**Resource consent application – Further information request**

Application number(s):	BUN60444262 / LUC60444264 / WAT60444263
Applicant:	Auckland Transport
Address:	Carrington Road, and 1, 99, 131 and 138 Carrington Road, Mount Albert
Proposed activity(s):	Improvements to Carrington Road between Mt Albert Town Centre and Point Chevalier Town Centre including road widening, construction of the Point Chevalier Watermain No.2 Project and associated construction activities

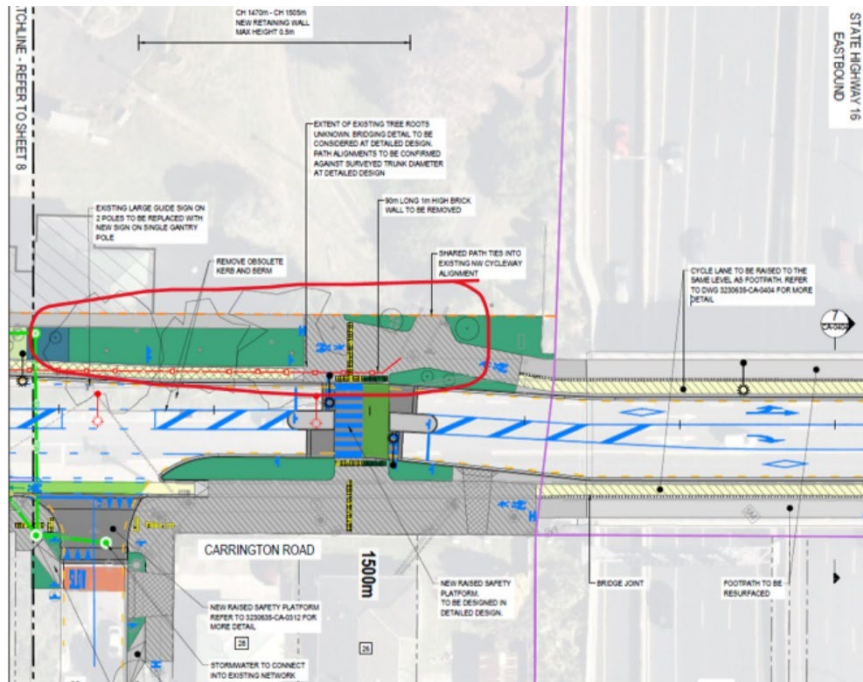
23. Please provide information to demonstrate why Airing Court Wall or part of the wall cannot be preserved in-situ. Please comment on any scope for changes to AT policy with regards to reduced lane widths for example.
24. Please provide details of the watermain isolation valve chamber proposed within the Historic Heritage Extent of Place. It is understood this infrastructure is below ground however please provide details of above ground access (photos will suffice).
25. Please confirm if an archaeological authority is being sought in parallel with the resource consent noting that Airing Court Wall is a pre 1900 structure.
